**AERONAUTICAL CHARTING FORUM**  
**Instrument Procedures Group**  
**Meeting 16-02 October 25, 2016**

**RECOMMENDATION DOCUMENT**

**FAA Control # 16-02-327**

**Subject:** Arrival Holding Patterns Required for Approach Entry

# RNAV (GPS) RWY 19R

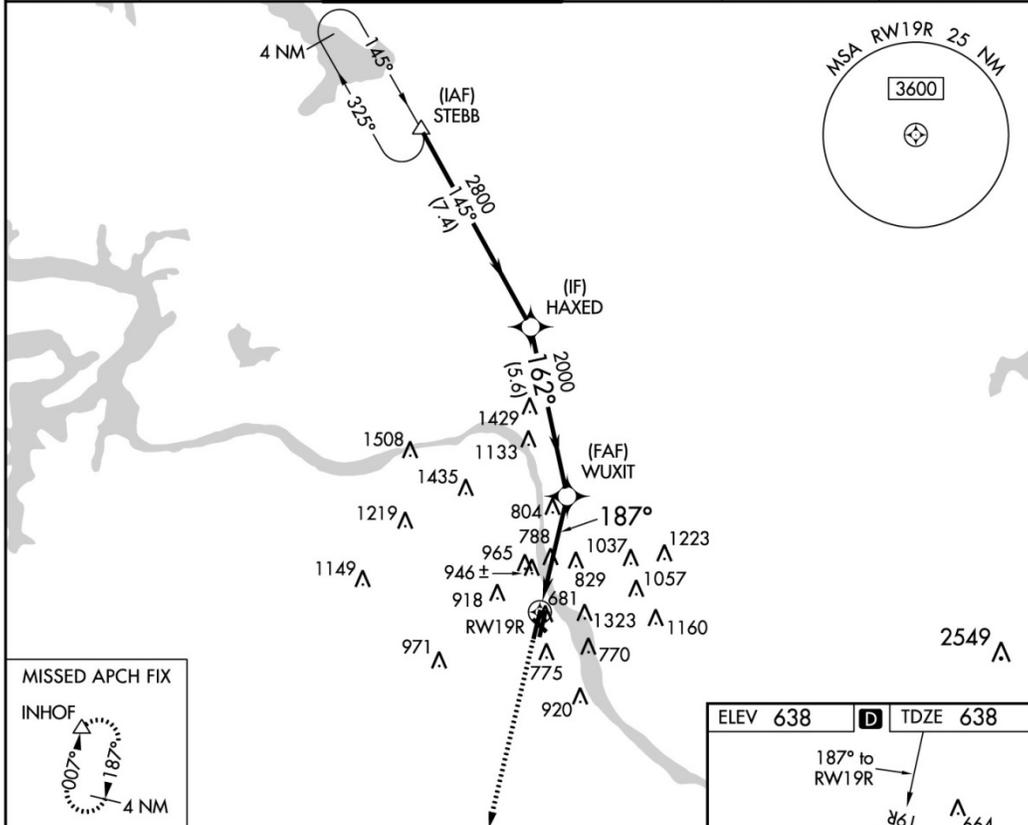
**Background/Discussion:** Recently, two RNAV IAPs were published with an arrival holding pattern that is required for procedure entry. One is a new RNAV Rwy 19R procedure at KRVS (attachment 1); the other is an amendment of the RNAV Rwy 30 procedure at KLRU (Attachment 2). For reference also attached are the former KLRU RNAV Rwy 30 (Attachment 3) and a snippet of the KLRU en route low-altitude area (Attachment 4).

These are two examples of an arrival holding pattern being a de facto HILPT, which is contrary to the intent of criteria and specifically prohibited by implementation policy in FAA Order 8260.19G. Based on input from NBAA, and follow-up by AFS-420, a NOTAM was issued prohibiting arrival on the KLRU RNAV Rwy 30 from V94 westbound or V611 southeast bound. The NOTAM removes some ambiguity to procedure entry but does not change the fact that the arrival holding pattern at MOLLY is a de facto HILPT. Note also the confusion at KLRU where straight-in on V94 from the west is permitted for the ILS Rwy 30 IAP even when RNAV navigation is used. (Attachment 5).
